H12146

## DESCRIPTIVE REPORT

Sublocality Vicinity of Bluff Point

# Descriptive Report to Accompany Hydrographic Survey H12146

Figure 1: H12146 Survey Outline and Junctions

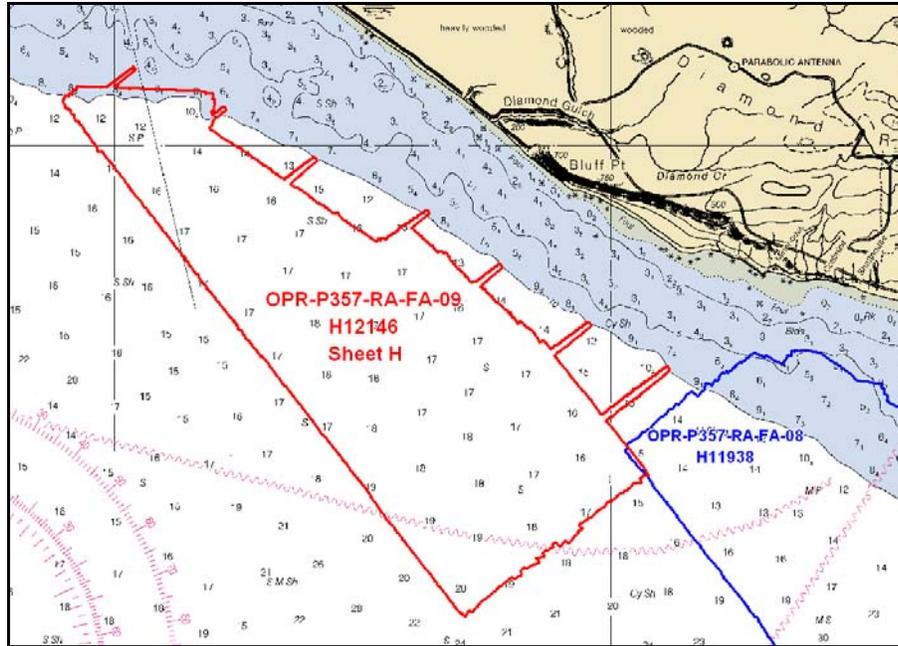
Survey H12146 junctions with survey H11938.<sup>4</sup> A CARIS BAG for H11938 was provided by Pacific Hydrographic Branch for junction comparison. H12146 BASE surfaces were compared to this junction surface in CARIS HIPS. The two surfaces agreed within 0.1 meters, and no discernable trends.<sup>5</sup> The sheet limits and area of overlap for H12146 and H11938 are shown in Figure 1.

<sup>4</sup> H12146 junctions with H11938 to the SE. A common junction was made with an adjoining portion of this survey.

<sup>5</sup> Concur. The areas of overlap were adequate and within specifications.

Figure 2: Resulting difference surface after subtracting the crossline data from mainscheme multibeam data

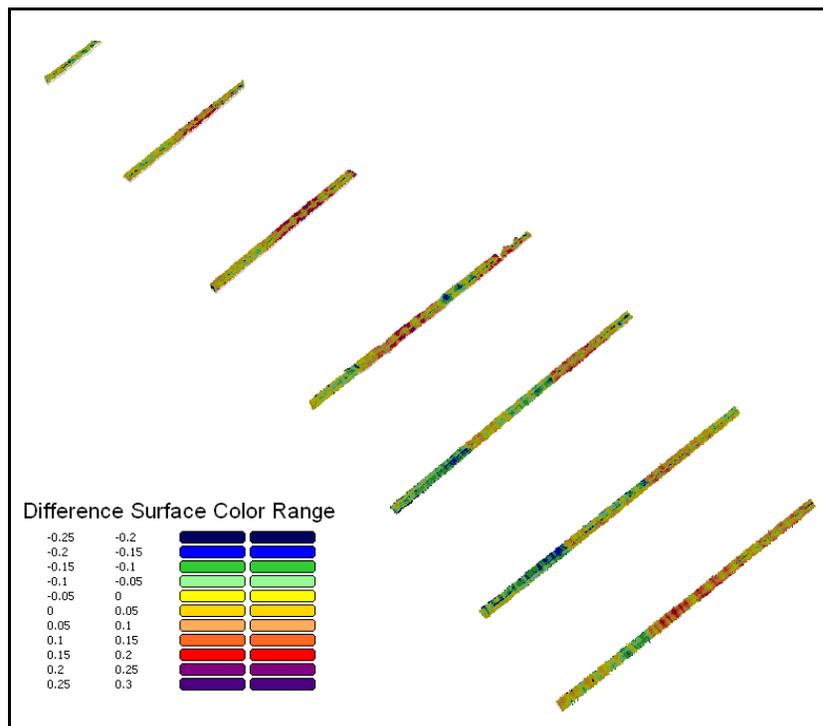
The main scheme bathymetry was compared to the crosslines in CARIS BathyDatabase by creating a differenced surface, subtracting a crossline surface from a main scheme multibeam surface. The difference surface is displayed below in Figure 2. Results show good agreement between crosslines and main scheme data with no greater than 0.3-m difference.<sup>2</sup>

<sup>2</sup> Concur.

Figure 3: Sound speed artifacts seen throughout survey H12146

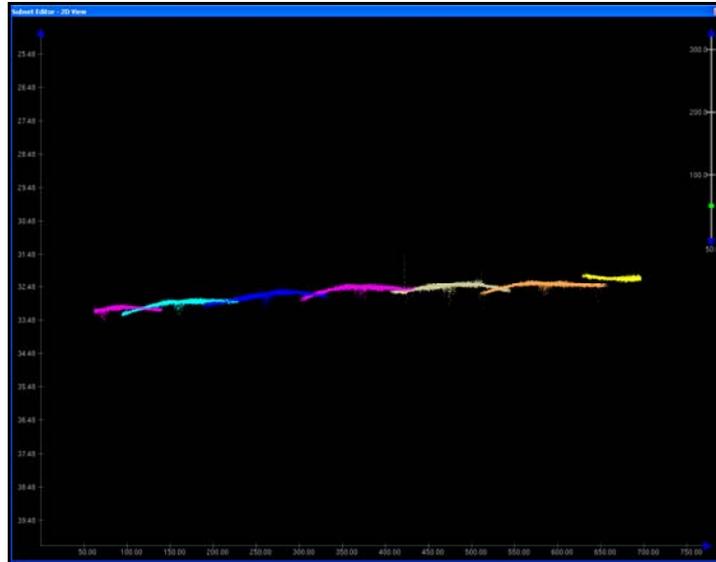
Due to fresh water runoff and the effects of tidal currents, the sound velocity profile was difficult to capture in the field, and sound velocity artifacts can be seen in much of the data from sheet H12146. Despite the best efforts of the Hydrographer to conduct sufficient sound velocity casts distributed both spatially and temporally, sound velocity errors were still noticeable in several regions. After correction for sound velocity in CARIS, some lines still exhibited the characteristic "smiles" and "frowns" indicative of inaccurate sound velocity corrections (see Figure 3). To compensate, the Hydrographer, where possible, rejected soundings obviously in error on the outer beams.<sup>6</sup>

<sup>6</sup> The data is adequate and within specifications to supersede charted data in the common area despite the SV errors.

Figure 4: Trough seen in raw data at nadir from data collected by launch 2801 on DN 250

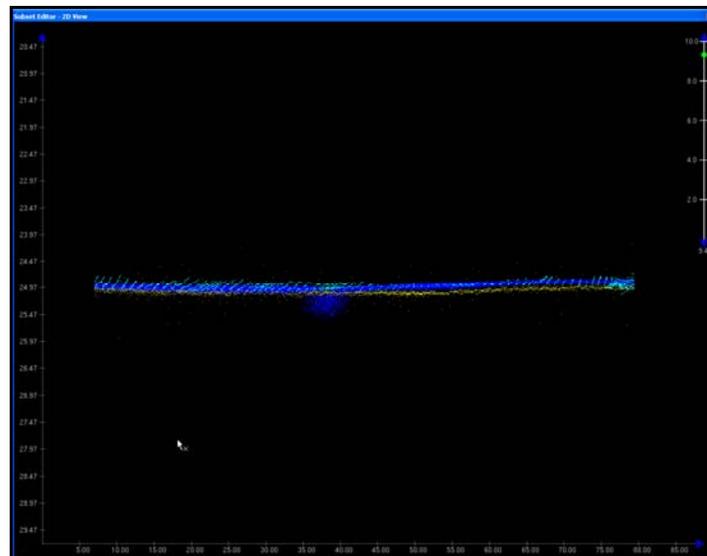
Data acquired by survey launch 2801 on DN 250 exhibited a trough at nadir, likely caused by excessive gain settings used during acquisition. Nadir beams, along-track, on average were found to be 0.30 m below the surrounding seafloor (see Figure 4), affecting the CARIS CUBE surface. To compensate, the Hydrographer, where possible, rejected soundings obviously in error at nadir.<sup>7</sup>

<sup>7</sup> The data is adequate and within specifications to supersede charted data in the common area.

Figure 5: Holidays, highlighted by red circles, caused by increment survey conditions from survey launch 2803 on DN 251

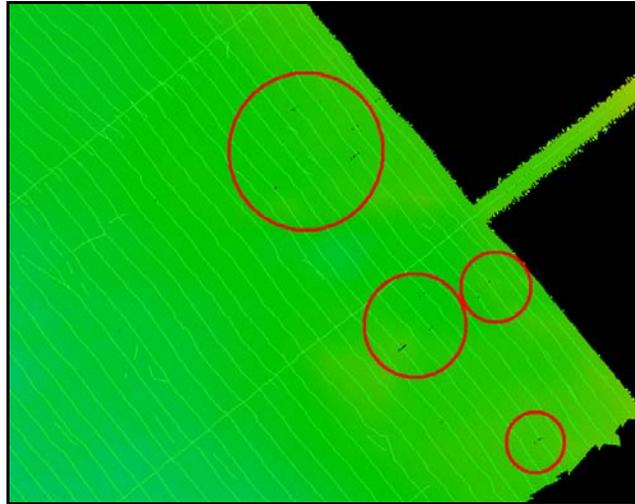
Several small holidays were noted in data from launch 2803 (RA-3) on DN 251, the last day of the survey, as indicated in Figure 5 by the red circles. Rough sea conditions during this acquisition day resulted in momentary loss of bottom track throughout the data. For holidays

larger than 3 nodes across, the corresponding multibeam backscatter side scan was examined and no navigationally significant items were found; additionally, the least depths were represented.<sup>8</sup>

<sup>8</sup> Concur. Areas around holidays were examined at PHB. There is no evidence of shoaling or significant features.

Figure 8: H12146 charted cable route.

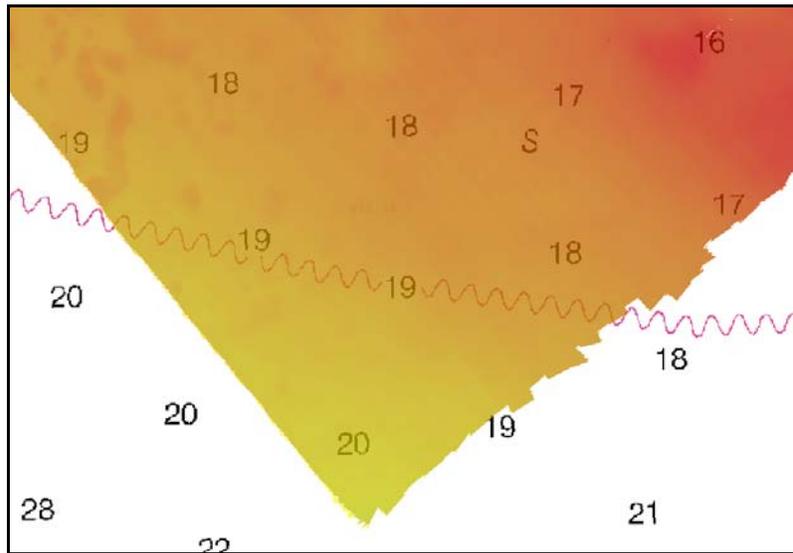
Survey H12146 includes one charted submarine cable route, as shown in Figure 8. No visible indication of cables was evident in the bathymetry in the southern corner of field sheet H12146\_C in the vicinity of the charted cable route. The Hydrographer recommends retaining the cable route as charted.<sup>18</sup>

<sup>18</sup> Concur with the hydrographers recommendations. A blue note was added to the HCell to retain the submerged cable.
